Goble, Colin
Serial No. 10/642,290

REMARKS

AMENDMENTS TO THE DRAWINGS

FIG. 2

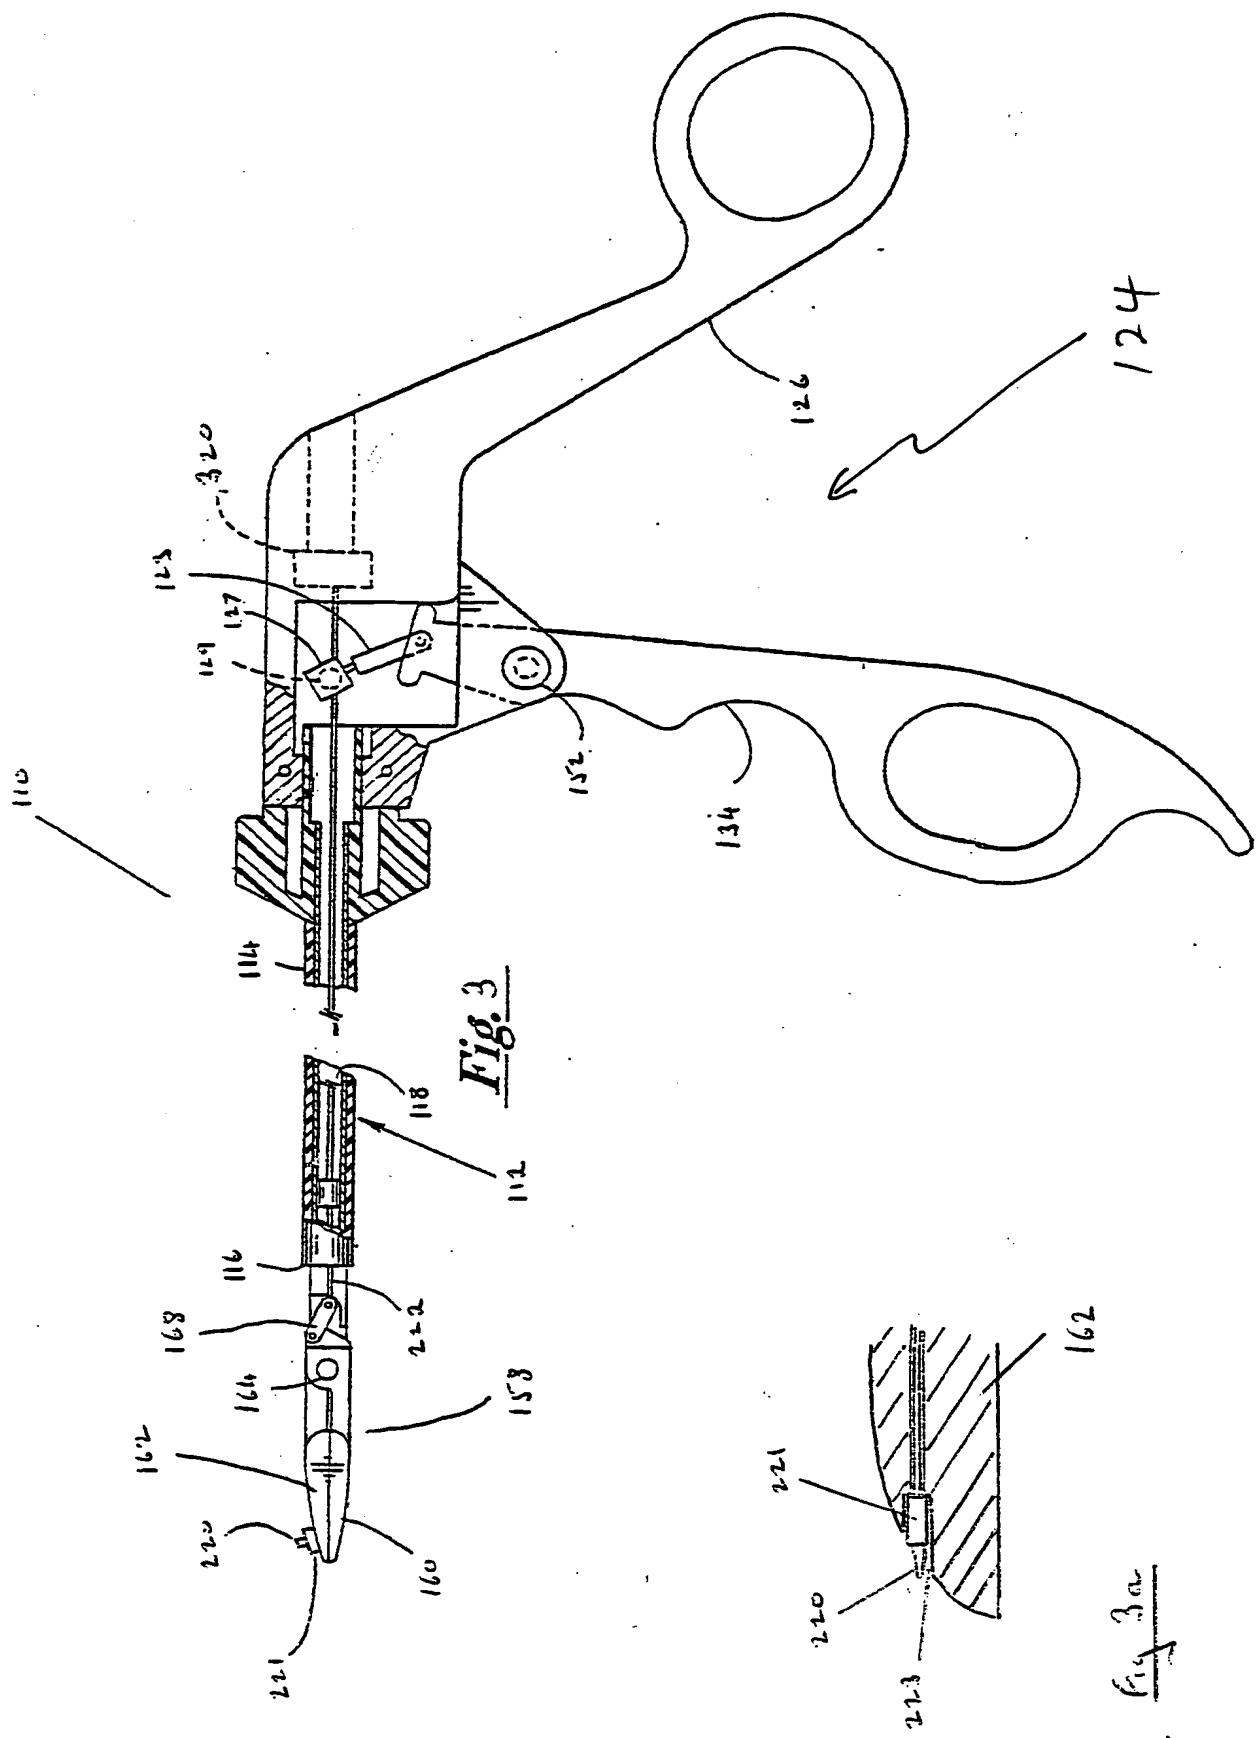
In Figure 2, sensing circuit 84 has been added, and is shown as being part of controller 72.

Fig. 5B

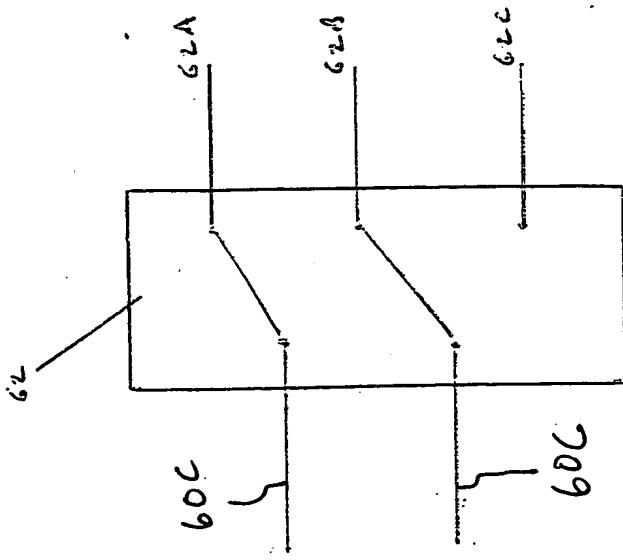
In Figures 5A and 5B, previously omitted reference numerals -- 60C -- have been added.

FIG. II

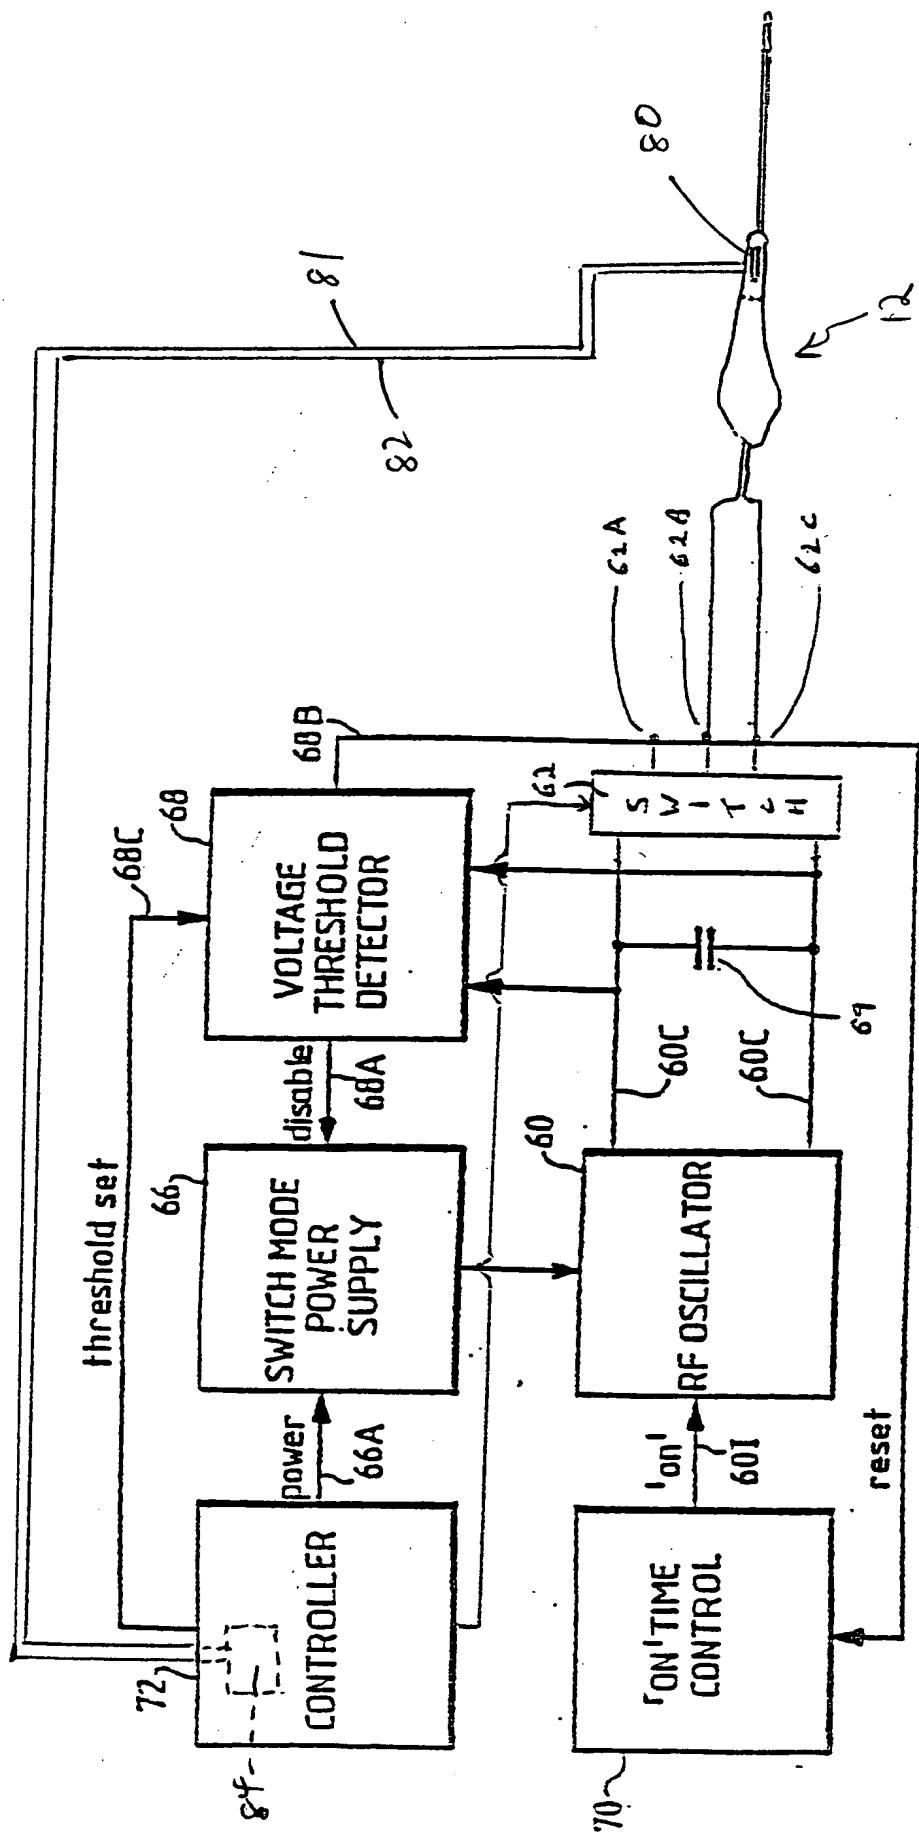
In Figure 11, sensing circuit 84 has been added, and is shown as being part of controller 72. In addition, previously omitted reference numerals --12, 80, 81 and 82 -- have been added.

FIG. 12

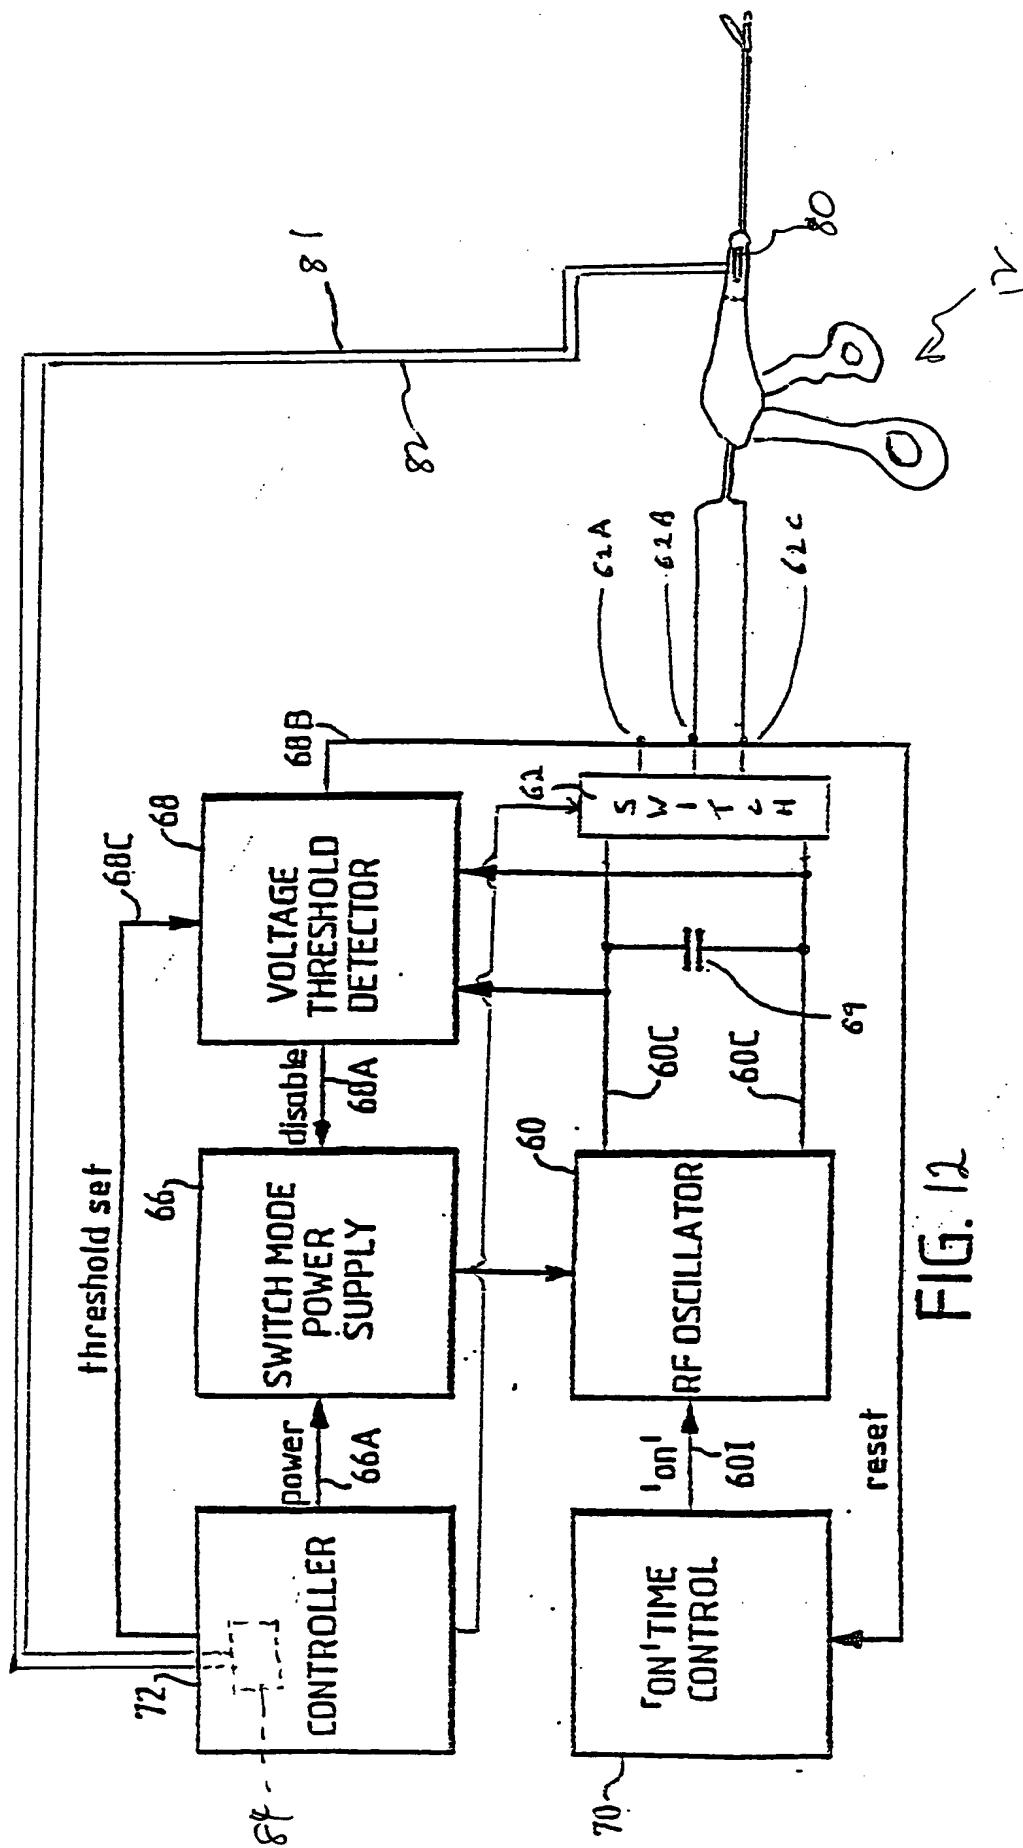
In Figure 12, sensing circuit 84 has been added, and is shown as being part of controller

72. In addition, previously omitted reference numerals -- 12, 80, 81 and 82 -- have been added.
